# SUBDIVISION REPORT - CONCEPT/DEVELOPMENT PLAN

► **FILE #:** 8-SB-25-C

8-G-25-DP

► **SUBDIVISION:** VALIARIANO PROPERTY ON BALL CAMP PIKE

## Type "B" Screen: Continuous

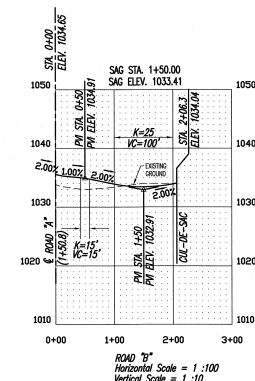
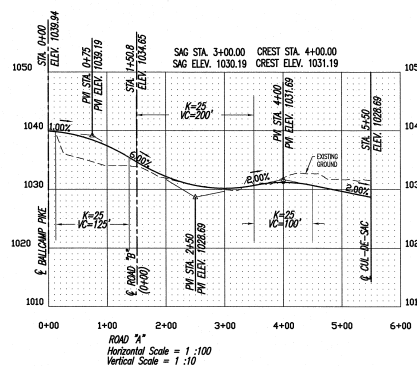
6. Providing a Type B landscape screen along the eastern boundary (Exhibit B). Existing trees that remain can count toward this requirement.
7. Certifying that the required sight distance is available along Ball Camp Pike in both directions at the Road A intersection, with documentation provided to Knox County Engineering and Public Works for review and approval during the design plan phase.

\*\*\*\*\*  
EXTERIOR  
ELEVATIONS 'A'

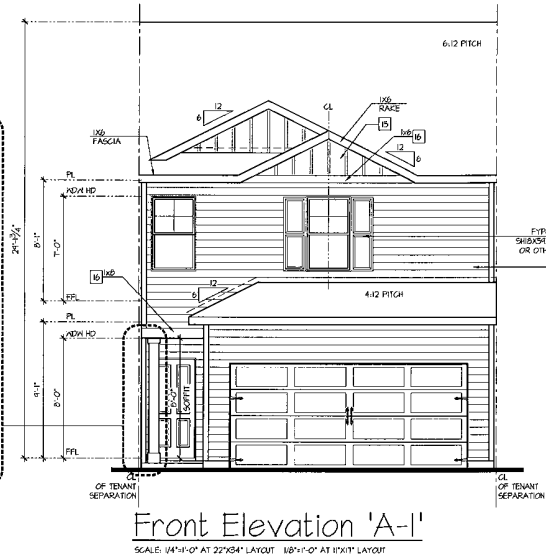
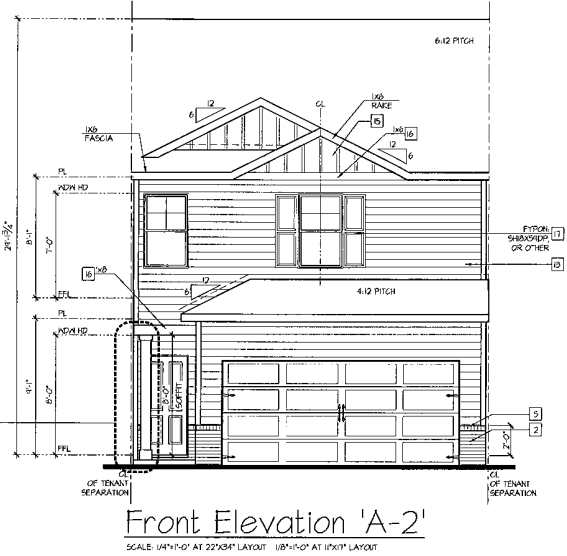
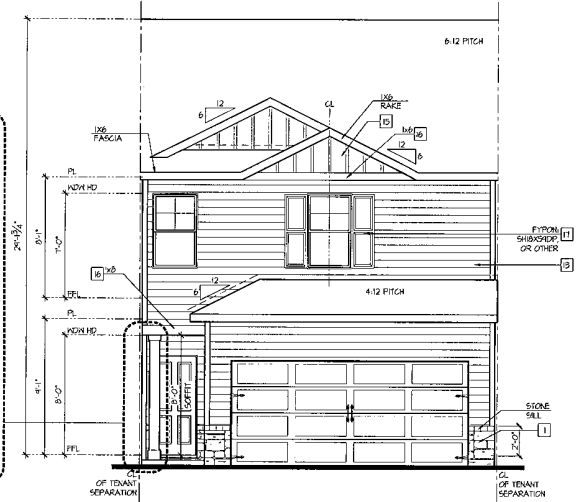
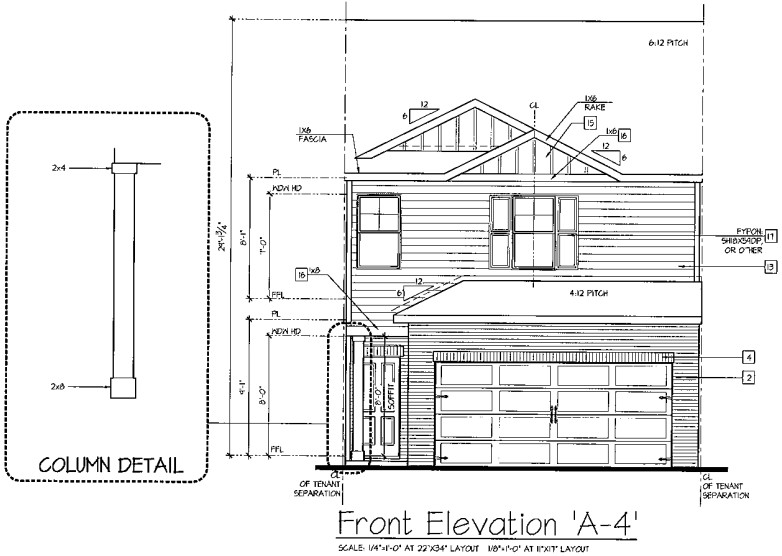
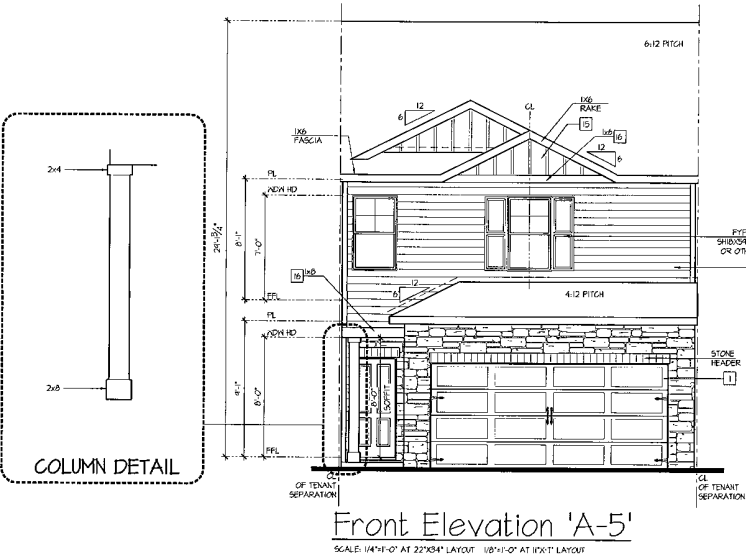
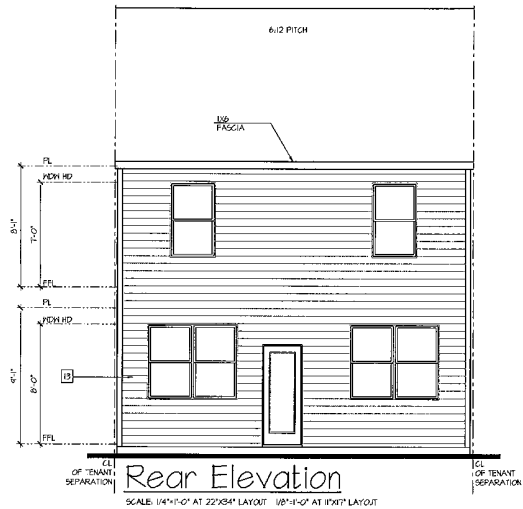
C. The height of attached houses shall be determined by the Planning Commission. The elevations provided show the units are 2 stories. The maximum height of all buildings will be 35 ft, which is consistent with the zoning requirements for residences in the area.

A. The property's land use classification is SR (Suburban Residential) on the Future Land Use Map. Attached houses are considered a secondary use in the SR place type. Attached residential structures such as duplexes, multiplexes, and townhomes should have the scale of a single family home. The attached houses are 2 stories, which meets these criteria.

1. Meeting all applicable requirements of the Knox County Zoning Ordinance, including the conditions of the rezoning case 11-A-24-RZ.
2. The maximum height will be 35 ft for attached houses.
